1 **BUSINESS LICNESE & PERMITS COMMITTEE**

10
11 **Re: Aura LLC. d/b/a Mickey Spillane's Kitchen**
12 **Unenclosed Sidewalk Café License # 1421245**
13 *350 West 49th Street (47th)*

Unenclosed Sidewalk Café Stipulations Application

PROPOSED PLAN,
ELEVATIONS AND
SITE PLAN

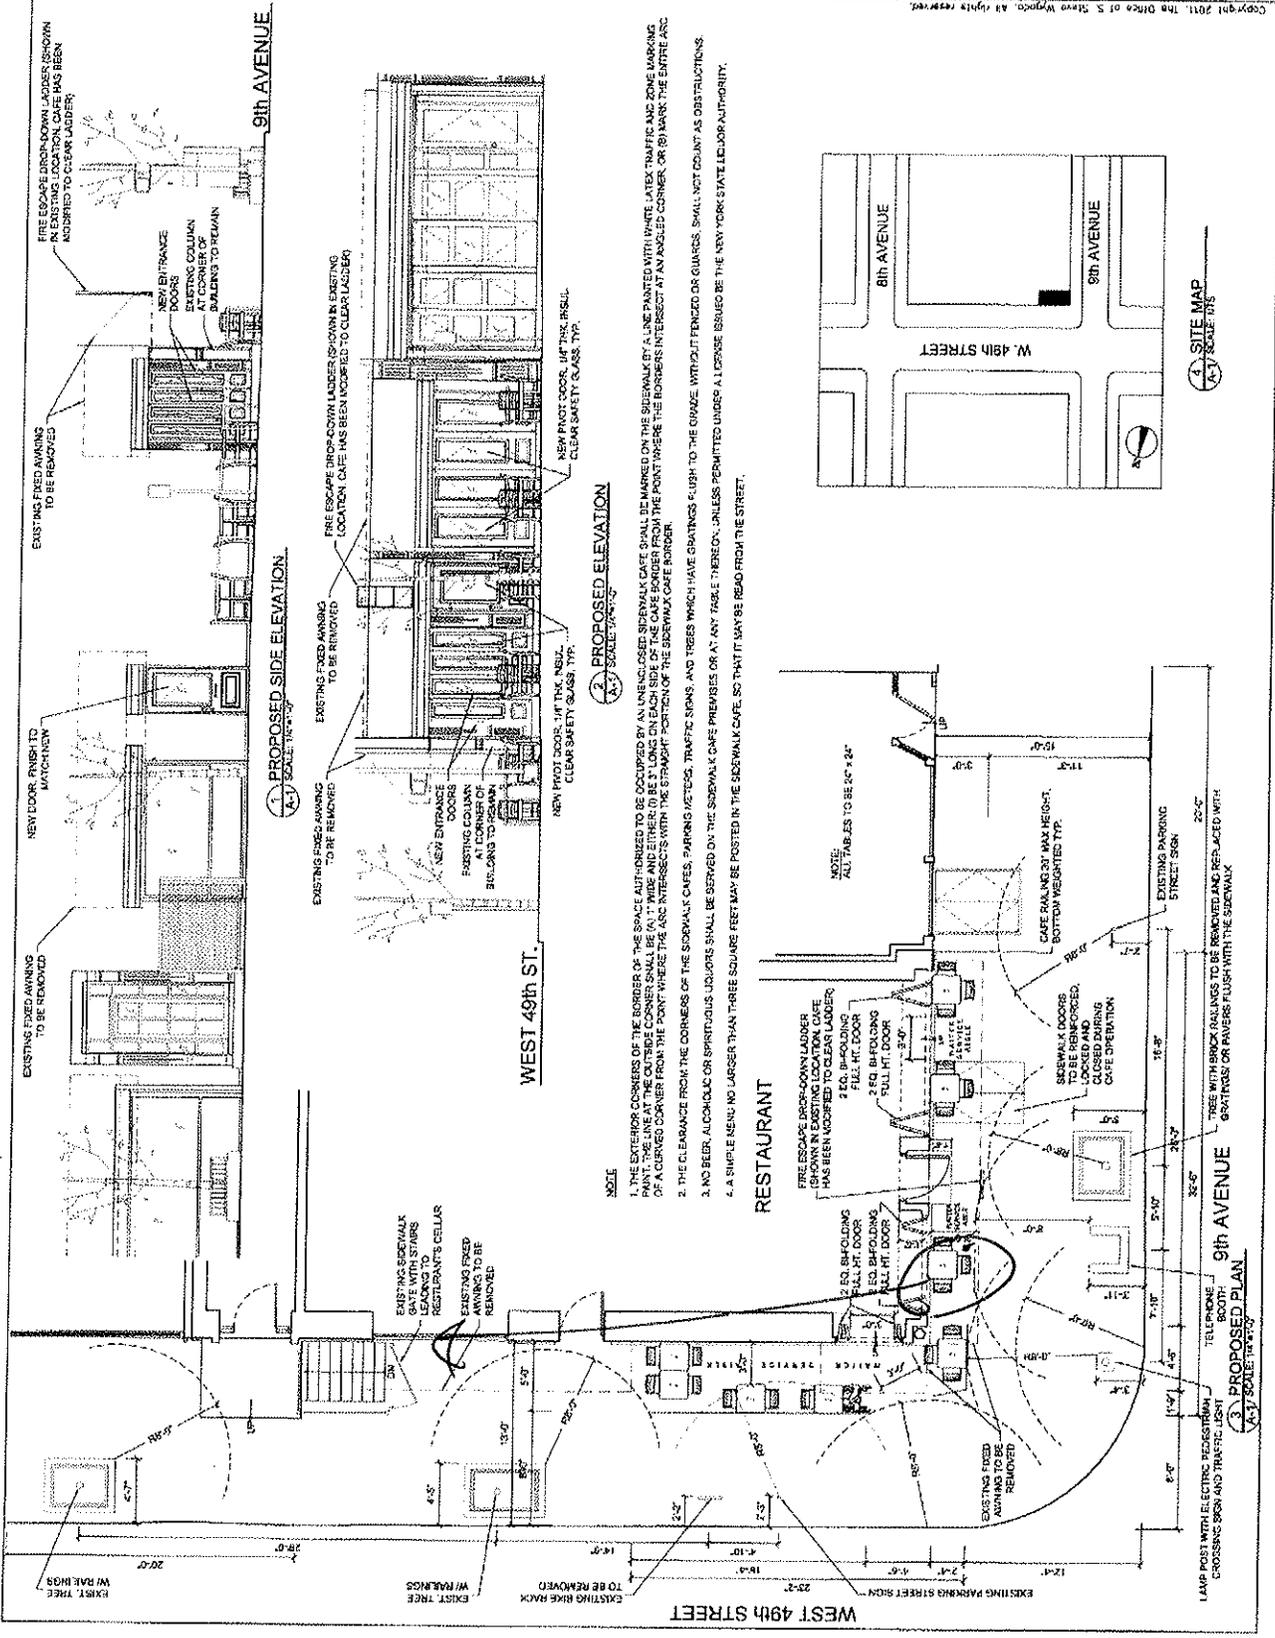
- **Applicant will remove a table as marked on the plans (see attached) and once the phone booth is removed the table may be moved back.**
